SERVICE BULLETIN

Classification: HA16-004a	Reference: NTB16-112a	Date: July 12, 2017
------------------------------	--------------------------	------------------------

2013-2017 ALTIMA; A/C DOES NOT BLOW COLD AND CLUTCH DOES NOT ENGAGE

APPLIED VEHICLES: 2013-2017 Altima Sedan (L33)

Figure 4

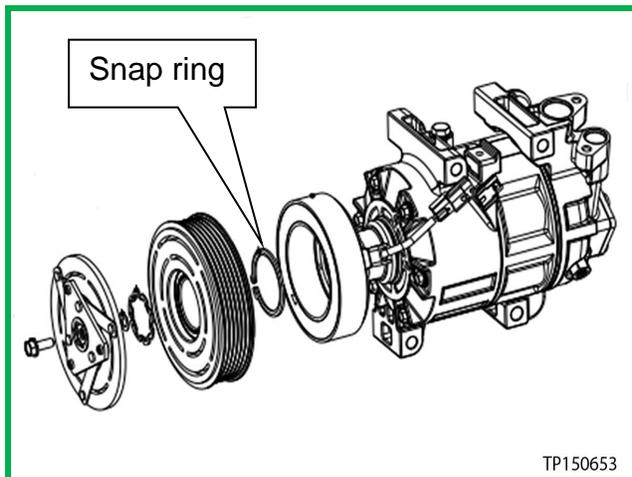
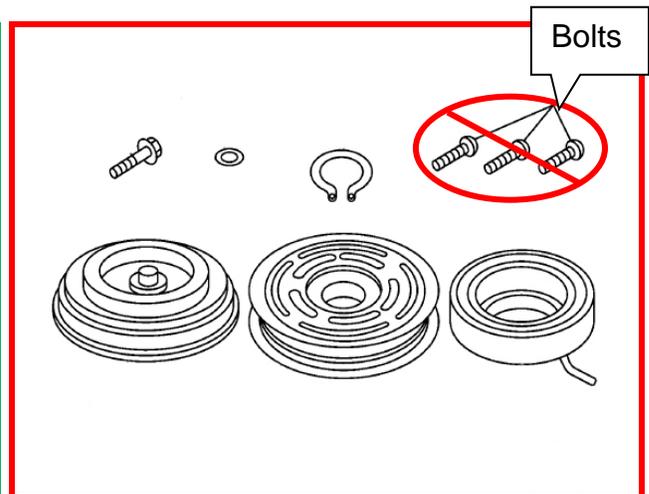
- The magnet coil for the applied vehicles is retained by a single snap ring as shown in Figure 4.
- Figure 5 (and illustrated in the ESM) is incorrect for the applied vehicles. The magnet coil is not attached by three bolts.

1. Replace the CLUTCH COIL ASSY-COMPRESSOR (magnet coil).
 - Refer to the Electronic Service manual (ESM), section **HA – Heater & Air Conditioning System** for replacement information.
 - See page 2 for required tools.
